YP Ashulia Ltd.

Jamgora Bottola (Moyna Market), Gorat Bagbari Road, Gazirchat Aliya Madrasha,
Ashulia, Dhaka-1349
(23.943494, 90.297852)
7 March 2024

1. Building Information

Observation-1: Inconsistencies in the design report and floor load plan. (Building-1)

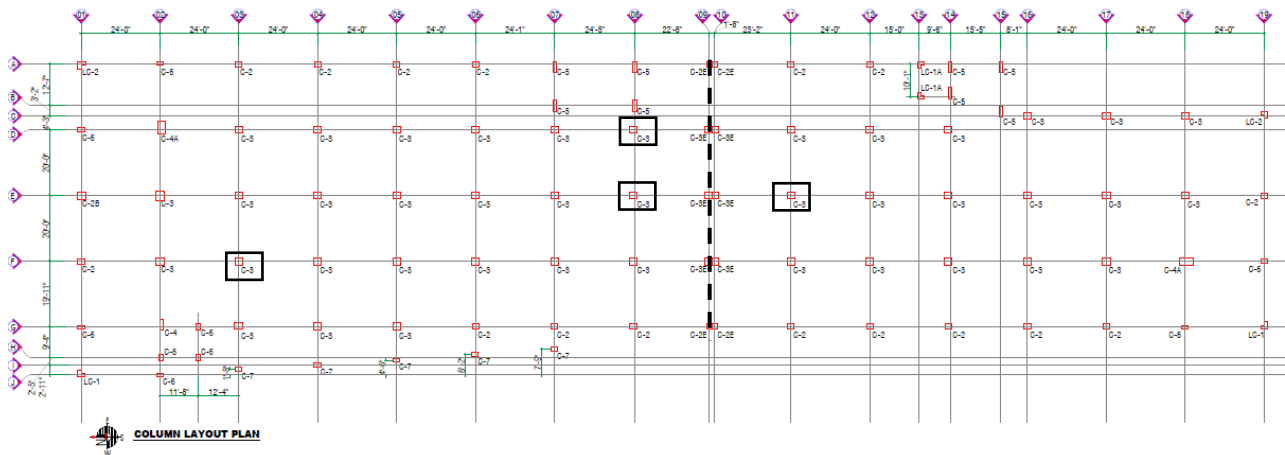
7 CONCLUSION /FINDINGS

According to BNBC loading condition-

- All foundation found adequate in size for bearing capacity.
- All foundation is found inadequate in thickness for punching shear capacity.
- 1 RCC column is found inadequate.
- 1 grade beam is found inadequate in reinforcement requirement.
- All of the floor beam are found adequate in reinforcement requirement.
- Soft Story exists in Ground Floor and 1st Floor in both directions.
- Torsional Irregularity exists in upto 3rd floor, only in Y-direction.
- The separation gap between slabs is not adequate.

Observation-2: Lack of material test report. (Building-1)

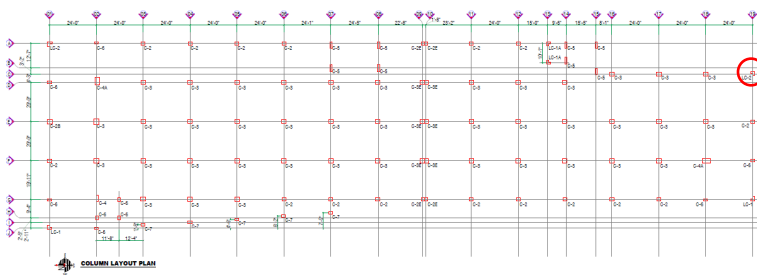
Description: There is an expansion joint in the middle of the building. Three concrete cores from columns are taken from one part and only one number from the other. The building engineer is required to take a minimum of four concrete cores from each part of the building and confirm the material design strength.

Observation-5: Trolley and vehicle impact (Building-1)

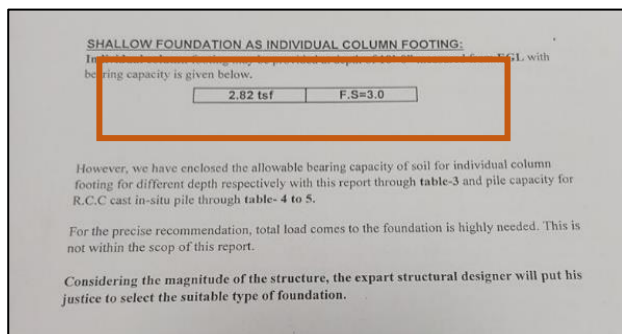
Description: Signs of trolley impact on columns and walls were found on several floors of the building. Also, the ground floor column at the loading-unloading zone is susceptible to vehicle impact. The factory is required to provide the necessary column & wall guards to protect against possible trolley impact and provide separate barriers surrounding the columns to avoid vehicle impact on them.

Observation-7: Inconsistencies in the design report and soil test report. (Building-2)

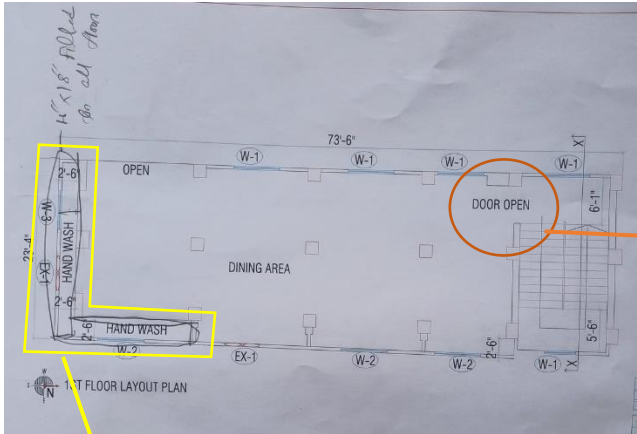
No design check for structural wall and overturning effect was found in design report.

Description: Foundation check of Building-2 was performed considering 7.56ksf instead of 5.64 ksf. Also, no design check was given for the shear wall in the design report. Building engineer is required to revise the design report with an overturning effect check as per Sec. 2.5.7.8 BNBC-2020 in addition to the above-mentioned issues and submit the revised design documents to the RSC for review.

Bearing capacity checked was performed considering 7.56ksf where footing depth is 2.1m from EGL.

Shear wall frame.

Observation 9: Lack of anchorage on roof water tank (Building –2).

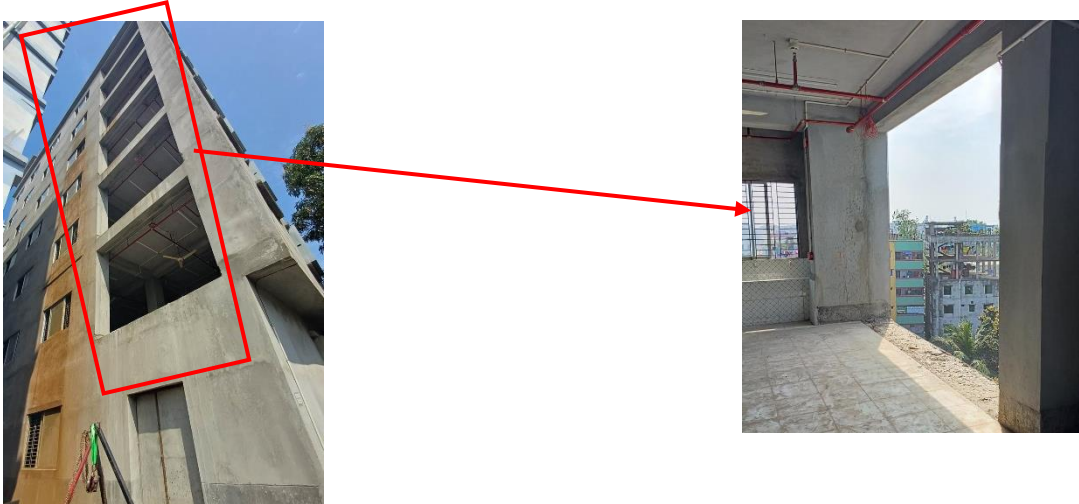
Description: Roof water tanks were found unbraced. The building engineer is required to brace/anchor all the non-structural elements, including the water tank.

Observation-11: Inconsistencies in the design report and concrete materials observed. (Building-3)

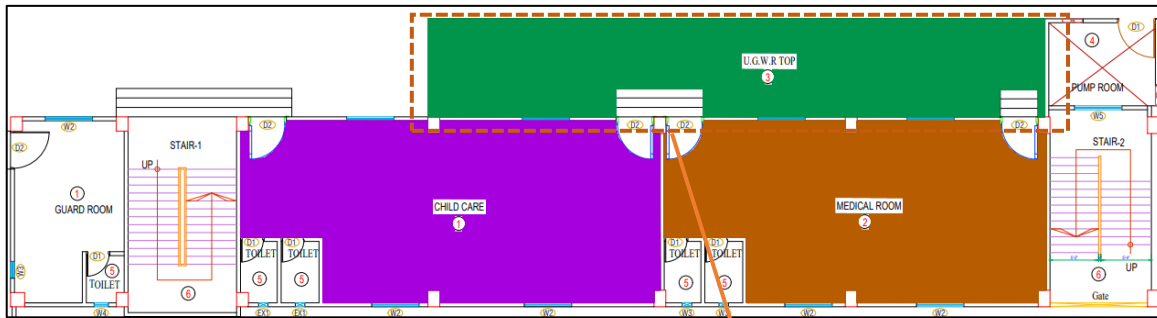
Design report used column concrete mechanical properties (young's modulus) for "Stone chips aggregates".

In ground floor column, brick aggregates was observed.

Description: Material properties mentioned in the design report and test report does not match with on-site observation. Brick aggregate was found instead of stone aggregate in the ground floor column. Also, no test report was found for the ground floor column. Building engineer is required to verify the in-situ concrete strength and incorporate it in the design report.

In material test report from water reservoir and floor slab, stone chips is mentioned. However, no test report was found from ground floor column.

Observation-15: Trolley impact on column (Building-4)

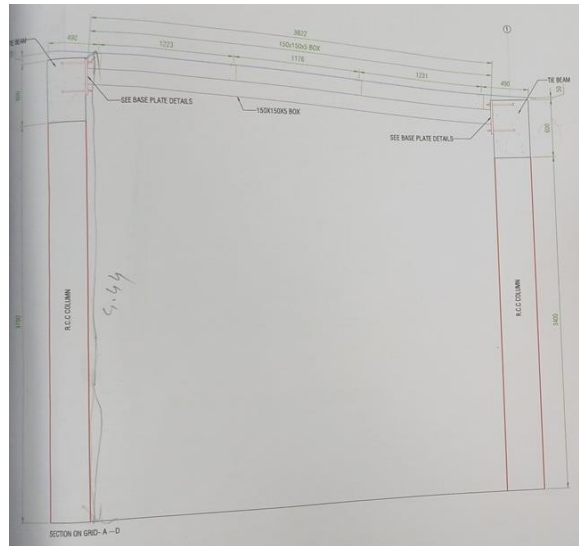
Description: A sign of trolley impact on the column was found. The factory is required to provide the necessary column guard to protect against possible trolley impact.

Observation-17: Mismatch in as built drawings (Building-5).

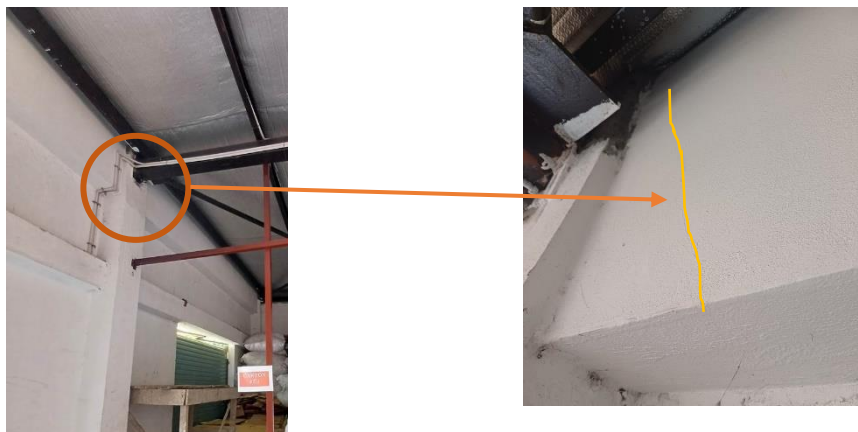
Description: During the inspection, the top height was observed at 4.44m instead of 4.8m. The building engineer is required to survey the structures and update the as-built drawings.
